CPP Project 6029

Lend Lease Project Management & Construction (Australia) Pty. Ltd.

Subject: Wind Engineering – Barangaroo South Concept Plan (Mod 6)

Figure 1: Ground plan of existing Mod 4 (L) and proposed Mod 6 (R) configurations

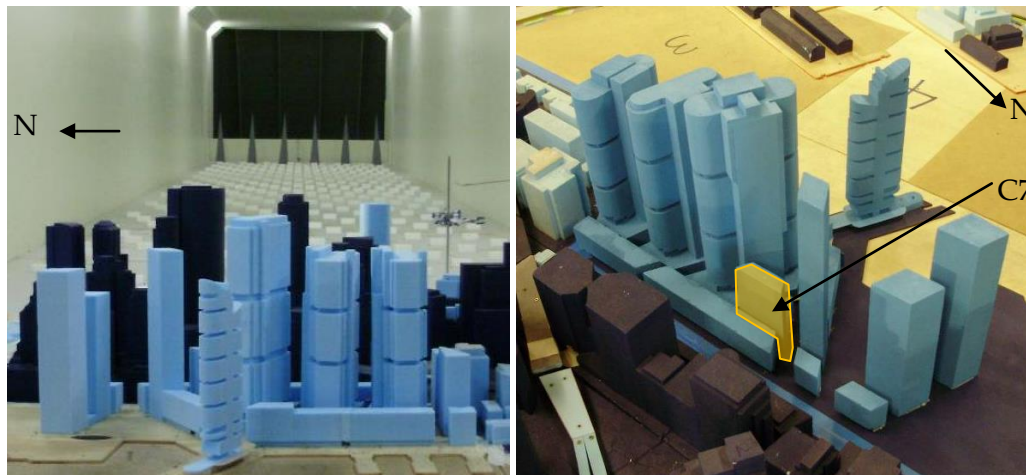
Please find herein comments regarding the impact of the architectural changes to the Barangaroo South development on the pedestrian level wind conditions. The drawings prepared for this S75W application have been reviewed and assessed from an environmental wind perspective at ground level. The only relevant geometric changes are the re-orientation of Globe Street, with the corresponding change in plan form of Buildings R11, R2, R3, C1, C3, and C8, Figure 1, and the removal of mid-rise building C7, Figure 2. The heights of the amended buildings are assumed to be similar.

Figure 3: Wind climate results for the Mod 4 configuration (T) and curved towers and realignment of Globe Street(B)

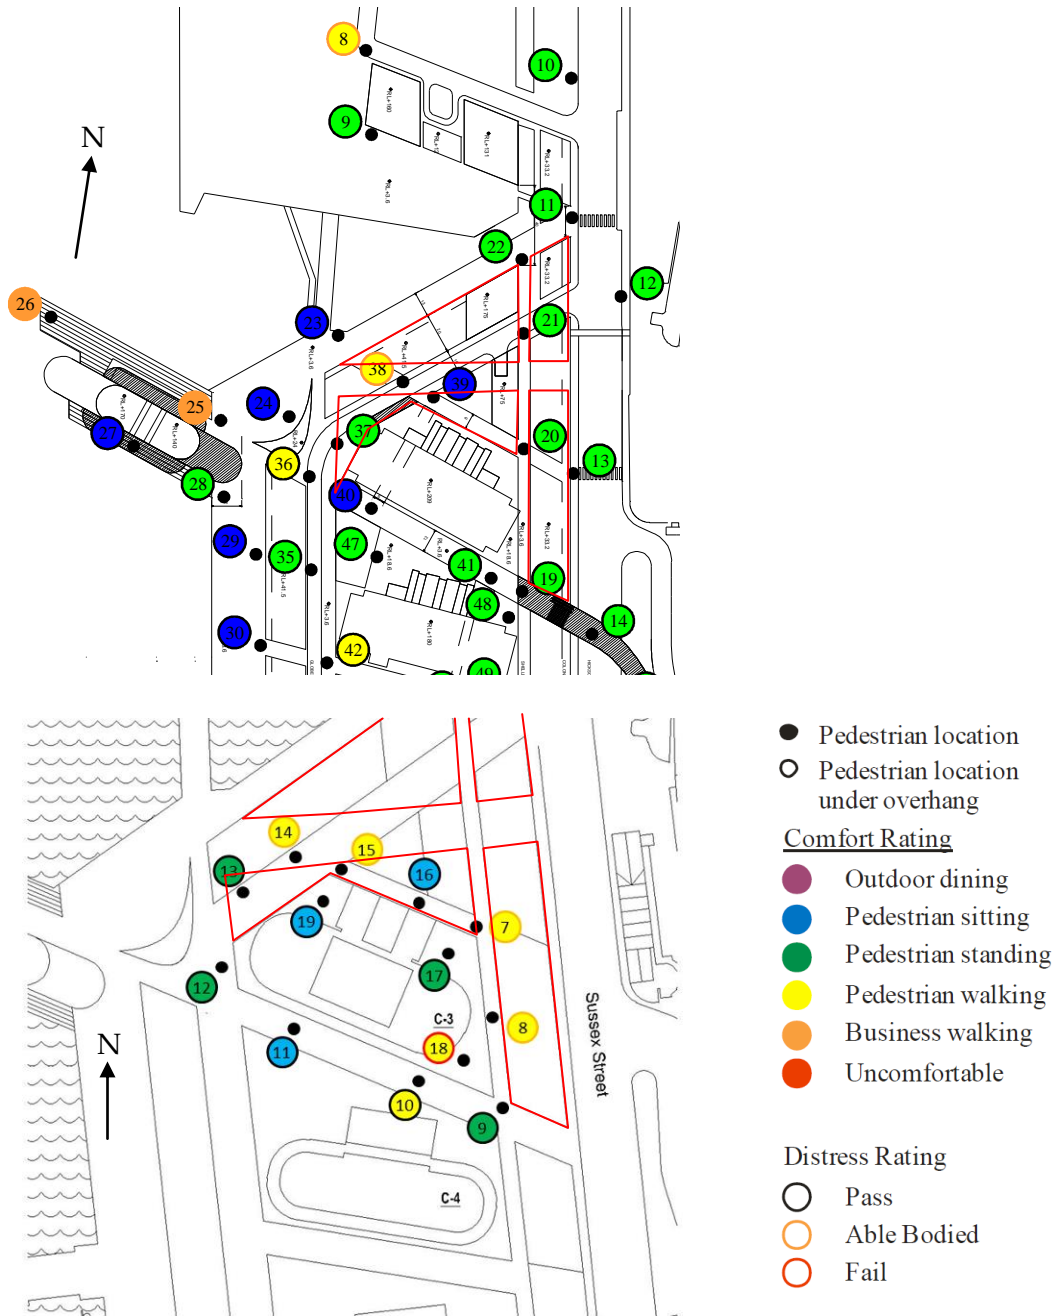
From a comfort criterion perspective the wind conditions around the site all met the pedestrian walking criterion, Figure 3, except around the base of the hotel protruding into the harbour. From a pedestrian level wind comfort perspective, the most important change from the Mod 4 to Mod 6 geometry is the increase in size of the Building C3 podium, marked in red in Figure 3. This increase in size is expected to improve wind conditions to the north of Building C3 and along Shelley Lane and Globe Street, by redirecting downwash from reaching ground level. The forming of a regular street grid pattern, particularly opening Globe Street to the west, will increase the ground level wind speed and the channelling of wind. Winds from the west will be channelled along Globe Street to the north of Building C3 causing windy conditions across Hickson Road. The rising topography to the east of the site and the lack of a continuation of the flow path across Hickson Road will ameliorate this condition and wind conditions are expected to remain suitable for pedestrian walking hence acceptable for the intended use of the space.

From a pedestrian distress perspective, apart from in the vicinity of the exposed hotel, there were five locations around the site that were classified as acceptable for 'able-bodied' pedestrians only; to the north-west of Building 4 (Location 8, Figure 3(T)), on Globe Street to the north of Building C3 (Location 38, Figure 3(T), and Locations 14 and 15, Figure 3(B)), and on Shelley Lane to the east of Building C3 (Locations 7 and 8, Figure 3(B)). Exceedances were marginal, with a twice per annum mean wind speed about 15.5 m/s compared with the criterion level of 15 m/s, Figure 5, except Locations 8

and 38 with the sharp-edged towers, and Location 7 with the curved towers, which had a wind speed between 17.6 and 18.4 m/s.

Figure 4: Directional results in the Mod 4 configuration with sharp-edged tower

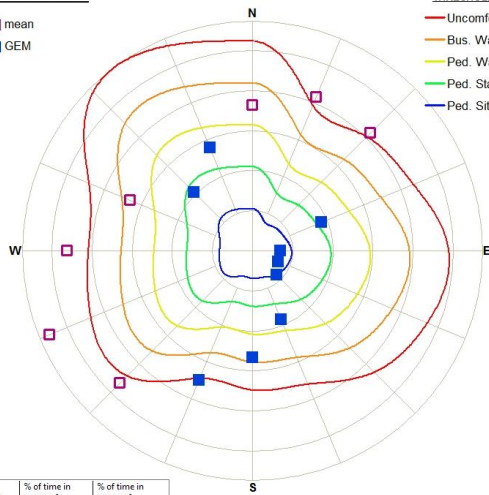
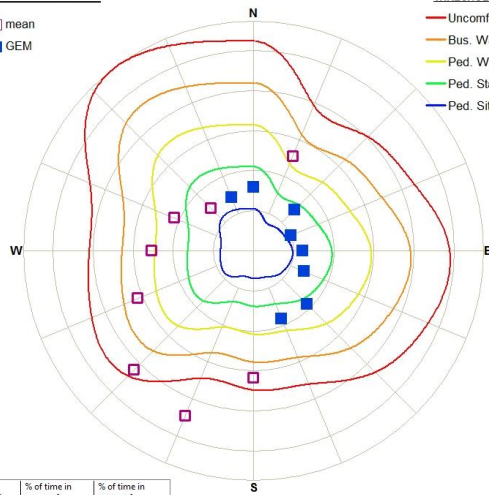
It is evident from Figure 4 that the locations are impacted by winds from the south-west and to a lesser extent from the north-east. The wind conditions at Location 8 are governed by downwash from Building R4 and the proposed changes to the buildings to the south will have negligible impact on the wind climate in this area being governed by the geometry and orientation of Building R4. Winds conditions at Location 38 are expected to improve with the increase in Building C3 podium size by redirecting

downwash away from reaching ground level for critical winds from the south-south-west.

Figure 5: Directional results in the Mod 4 configuration with curved towers

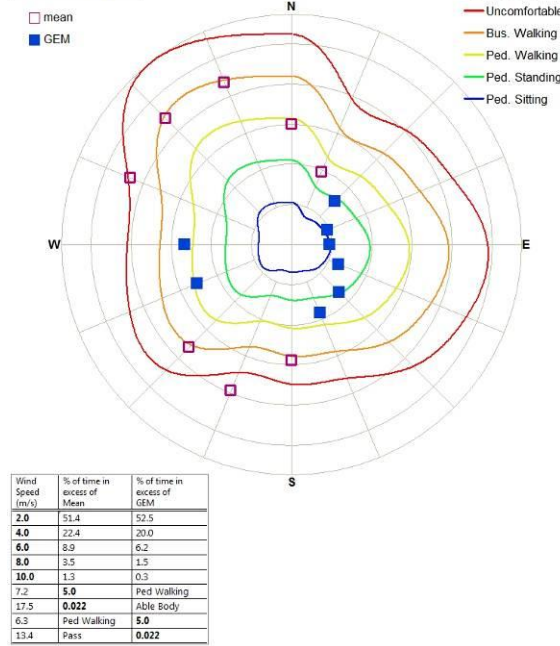
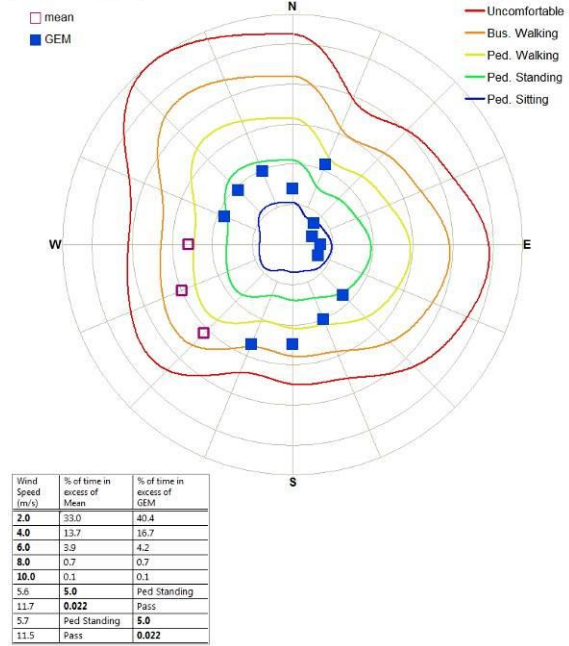
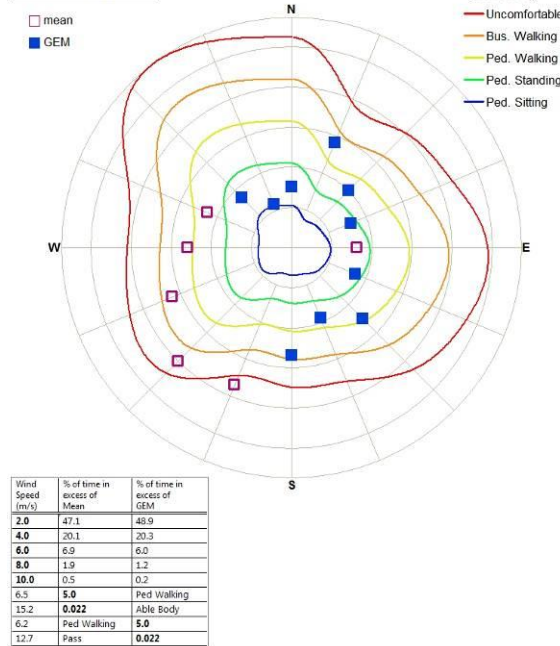
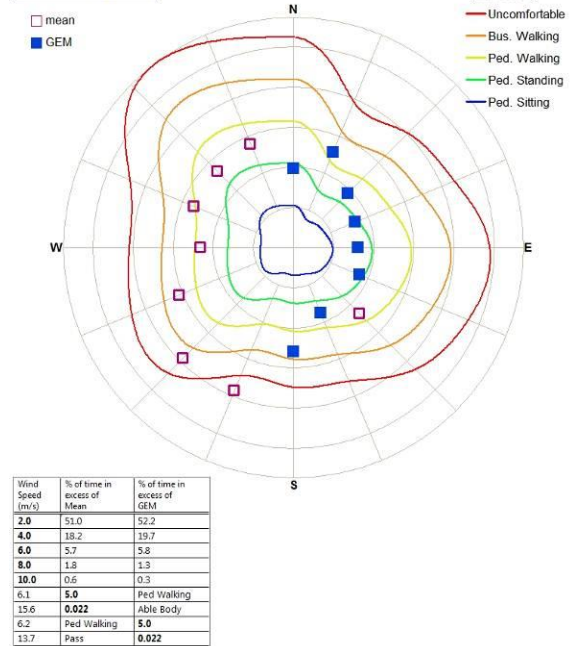
It is evident from Figure 5 that Location 7, on Shelley Lane, was impacted by winds from the south-west and north-west quadrants. Both these wind directions induce downwash from Building C3 at this location. Winds from the south-west are channelled between Buildings C3, C4, and the hotel on the peninsula and brought to ground level by the massing of the tall buildings. Winds from the north-west are brought to ground level by the massing of Building C3. With the increase in podium size to the north of Building C3, a portion of this downwash will be redirected away from reaching ground level and will pass over the roofs of Building C1/C8. The re-direction of flow is expected to improve the wind conditions in this area.

Locations 14 and 15 marginally exceed the distress criterion and are classified as suitable for 'able bodied' pedestrians. The conditions are caused by strong winds from the south-south-west, Figure 5. These conditions are calmer than Location 38 in Figure 4 caused to a large extent by the curved ends of the towers, but the flow is still accelerated between the hotel and the Building C3 and C4. The increase in size of podium to the north-west of Building C3 and to the south of R3, is expected to improve the wind conditions in this area.
